**IN THE MATTER** of Plan Change E:  
Roxburgh Residential Area -  
Rezoning from Industrial to  
Residential Zone

**STATEMENT OF EVIDENCE OF KATHERINE JOHNSON  
BLAGROVE and JAIME MARY JOAN DEVEREUX  
ON BEHALF OF FRANCES HOLDINGS LTD  
5 APRIL 2025**

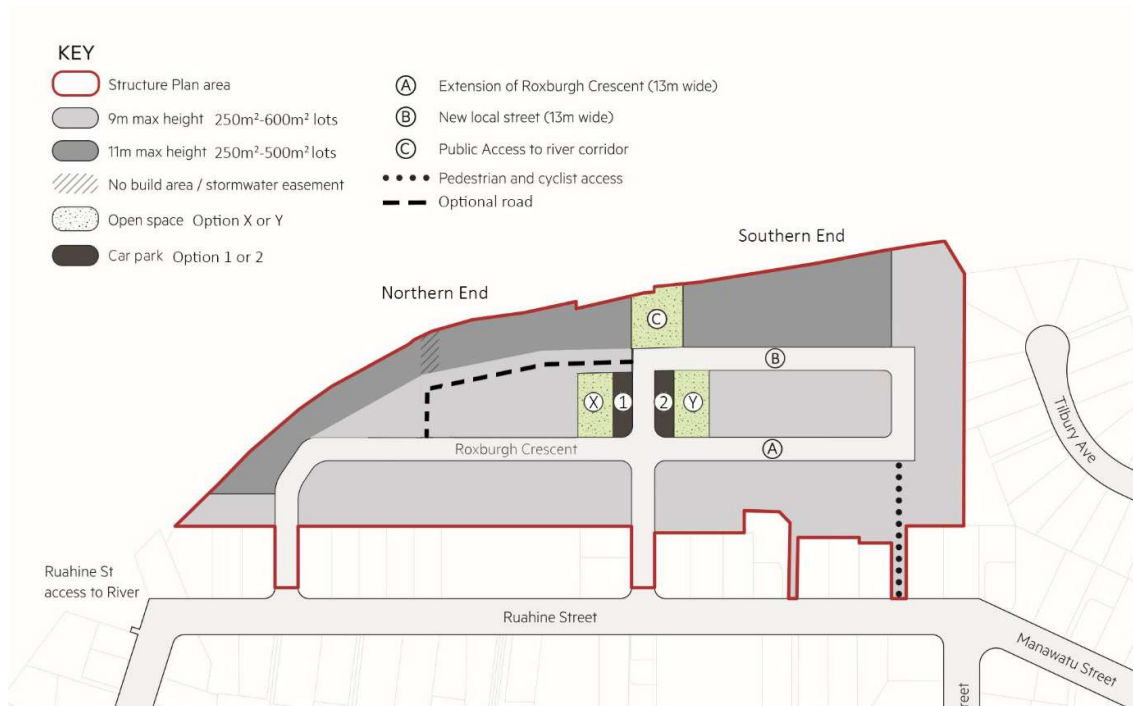
- 3.1. I support the overarching urban design outcomes promoted by the McIndoeURBAN report: a connected, compact, diverse, and well-integrated neighbourhood. However, the scale and constraints of the site warrant a more flexible planning approach.
- 3.2. While the notified provisions allow for activities not in 'general accordance' to be considered discretionary, in practice this creates a strong disincentive to innovate or depart from prescribed layouts. A more outcome-focused framework would reduce consenting risk while still securing the urban outcomes sought.
- 3.3. I recommend refining the Structure Plan and associated rules to:
  - Enable flexibility in lot sizes and housing typologies
  - Allow the location of the reserve on either side of Road D
  - Maintain key river and pedestrian connections

- Provide for private accessways where appropriate

3.5. An example of how this could look is included below:
